GENESEE COUNTY PLANNING BOARD REFERRALS NOTICE OF FINAL ACTION

V-02-ATT-12-25

Site Plan Review to construct a new drive through restaurant (Tim Hortons).

140 Prospect St., Attica

SITE DIMENSION PLAN

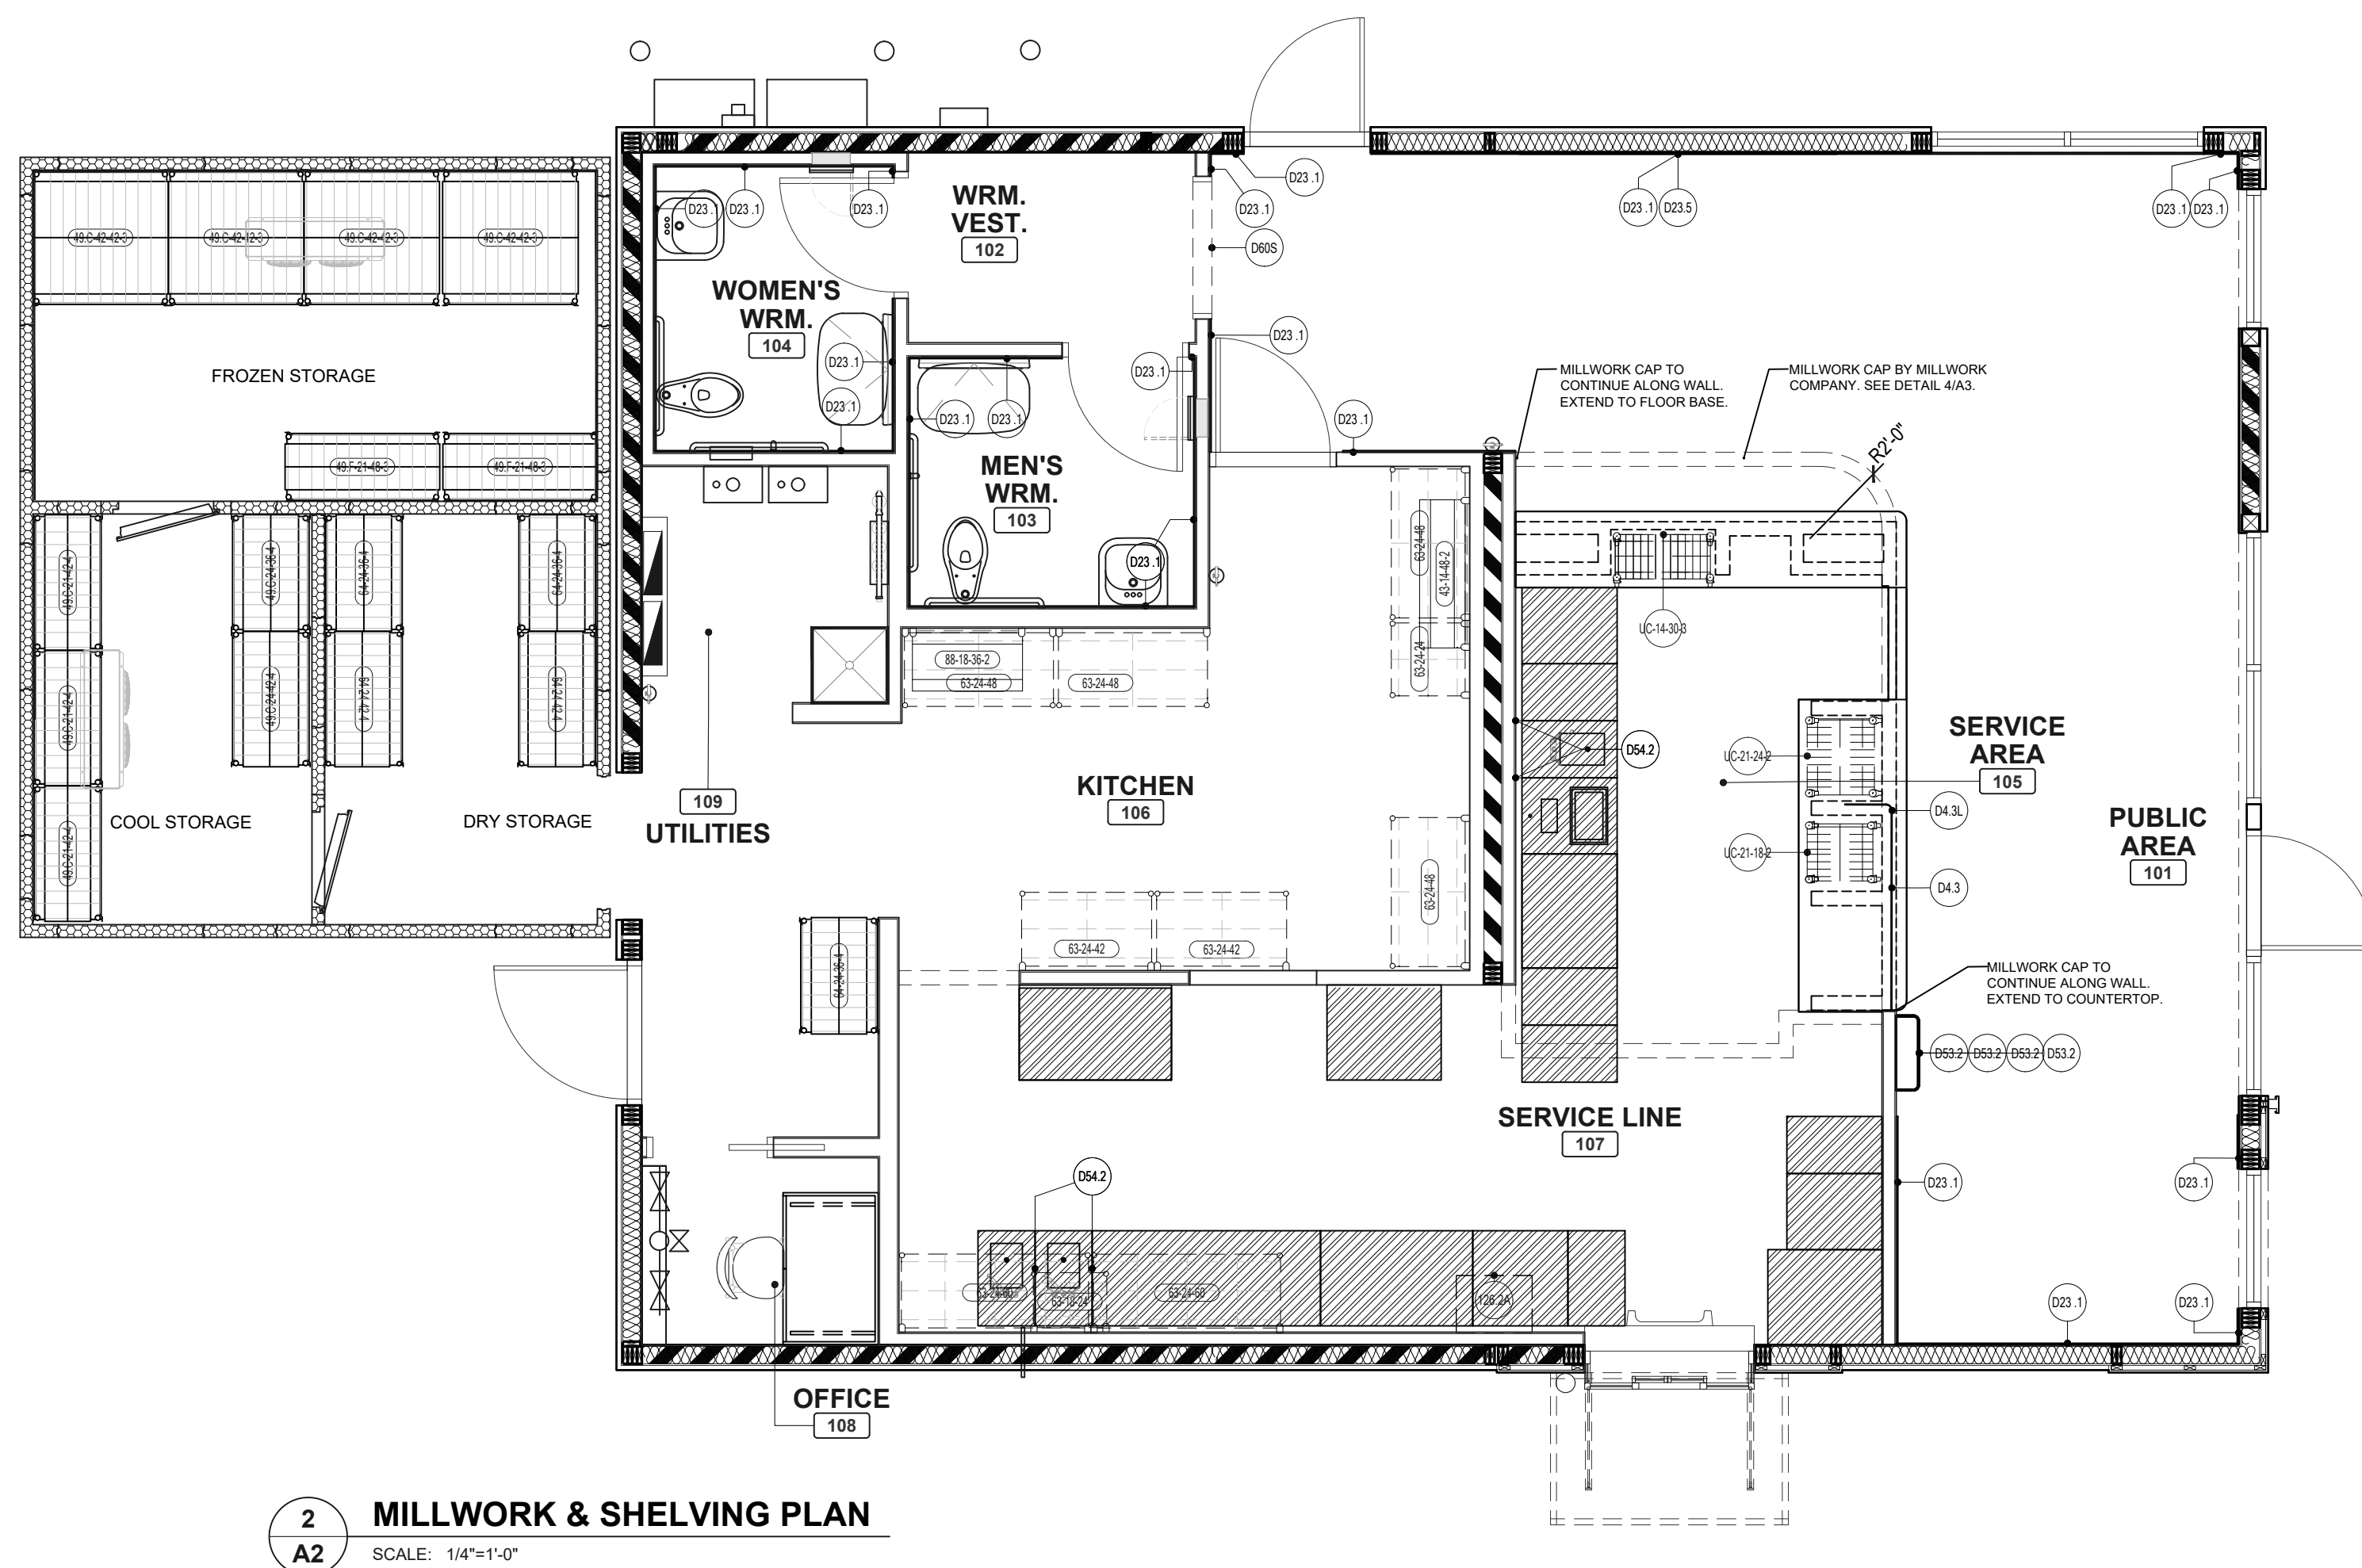
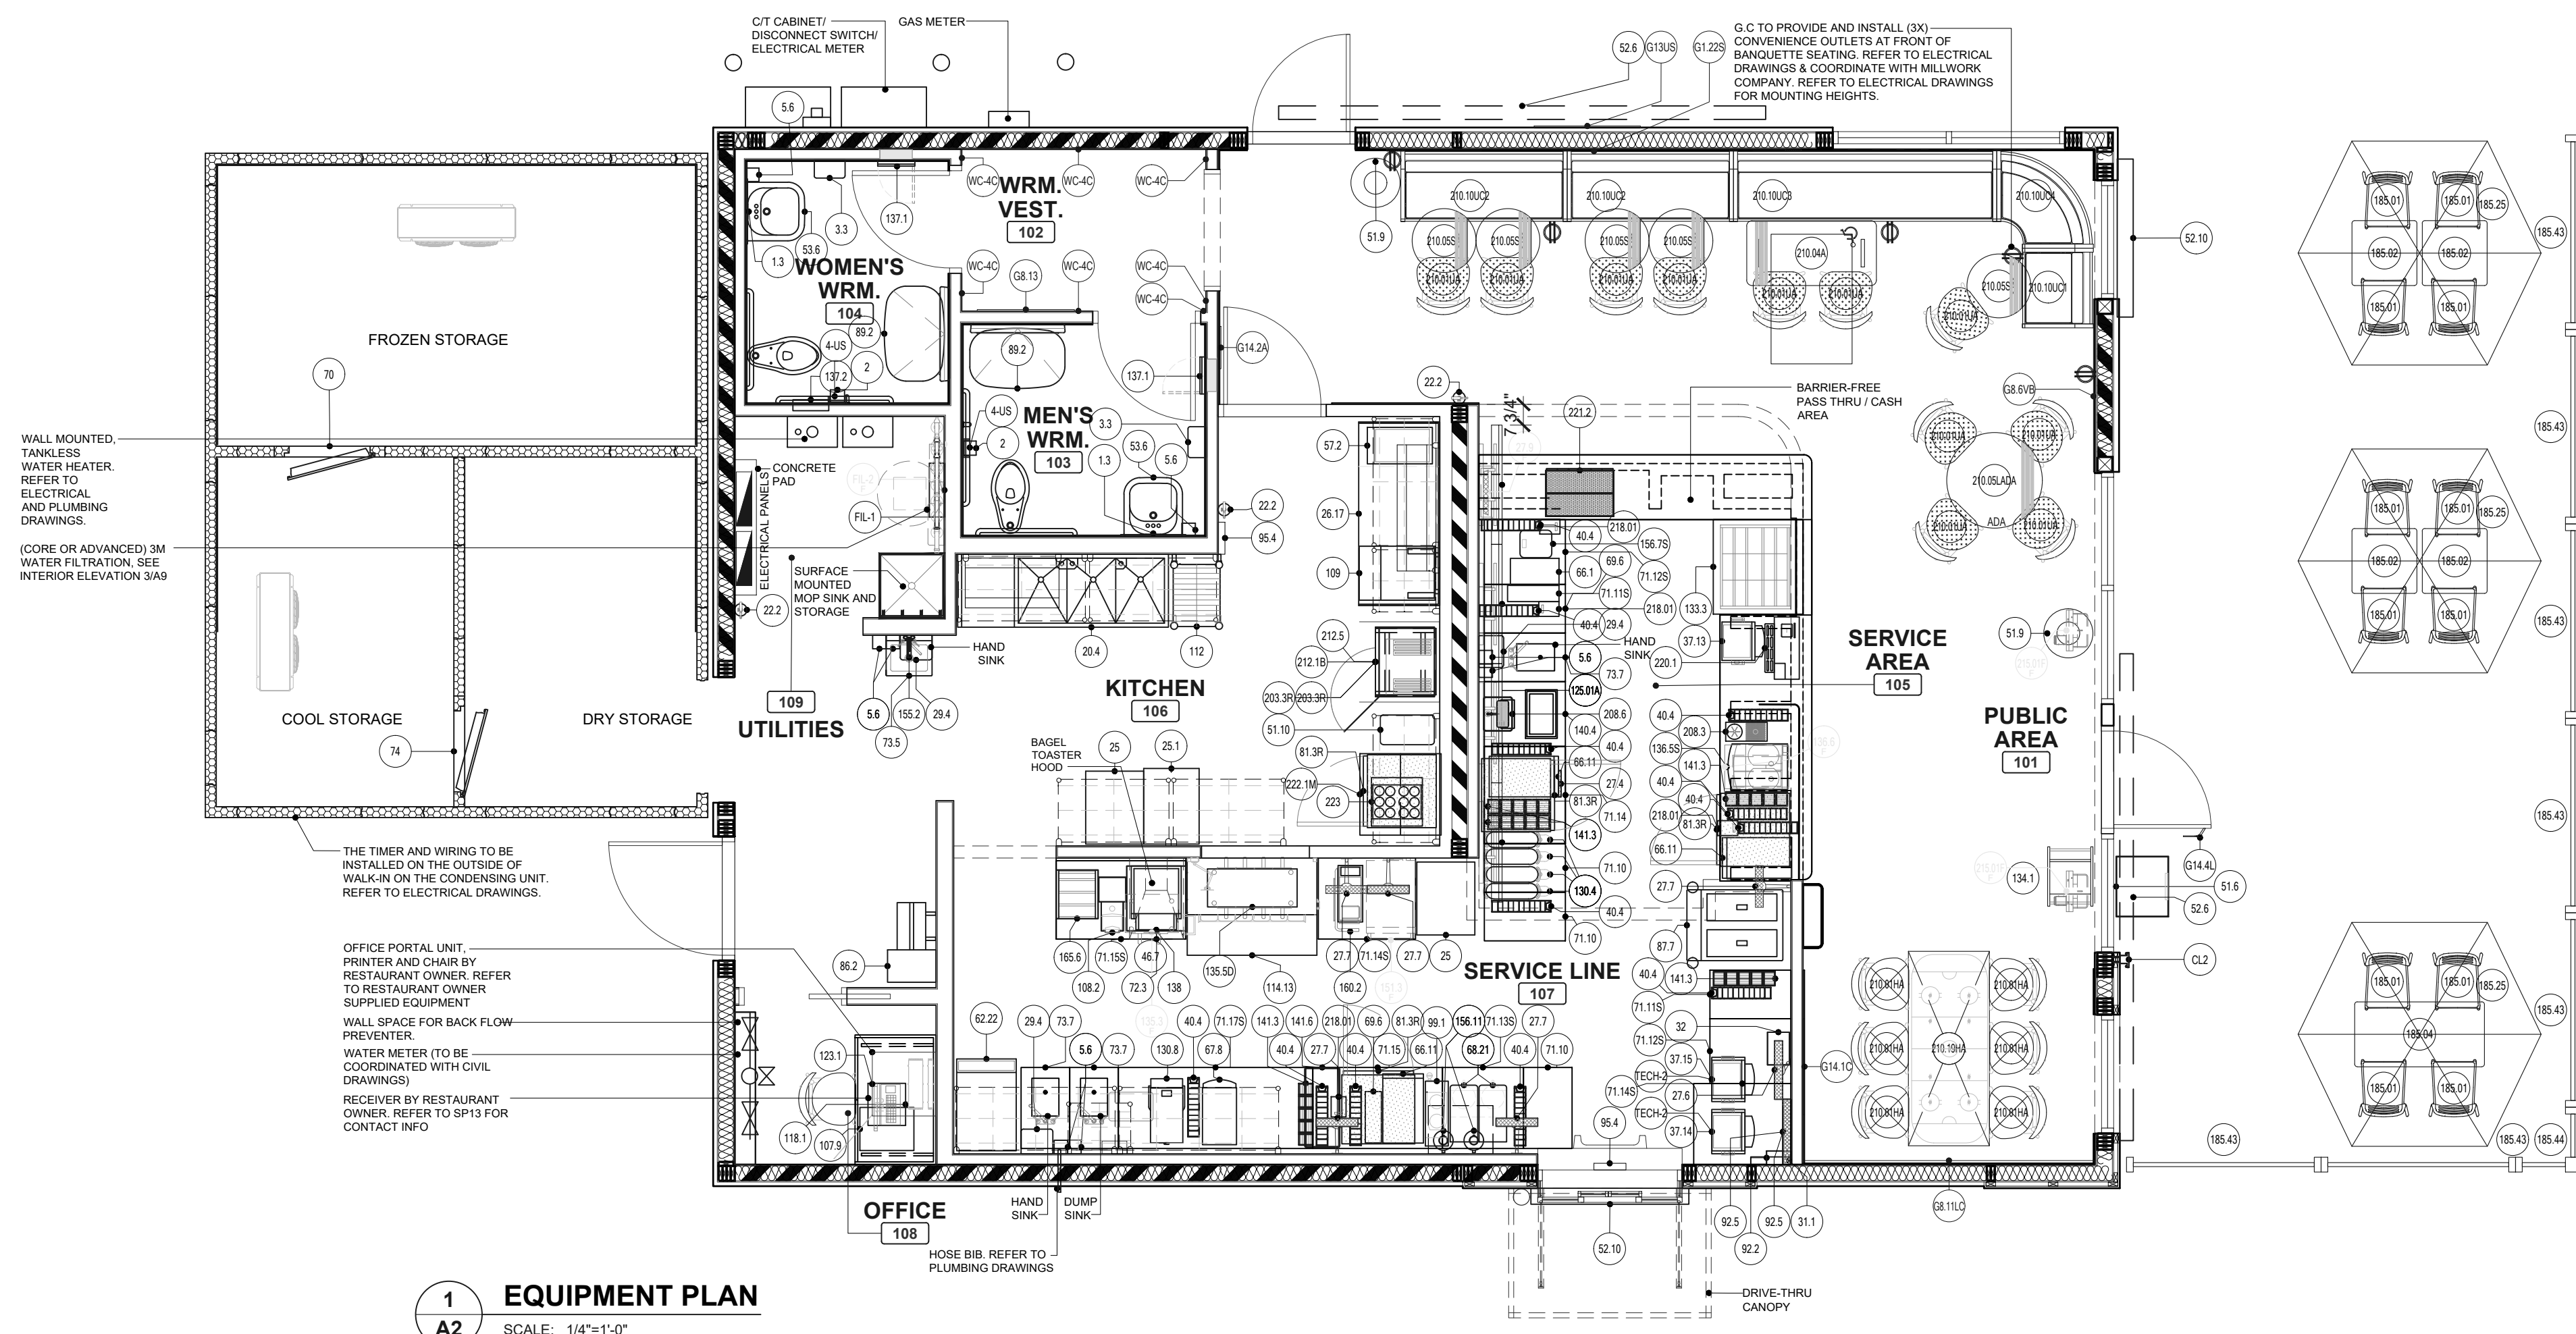
The required modifications are as follows: 1) The applicant provide documentation to the Village Planning Board on the adequacy of the drive through stacking proposed; and 2) The applicant provide a landscaping plan acceptable to the Village Planning Board. With these required modifications, the proposed drive through restaurant should pose no significant county-wide or inter-community impact.
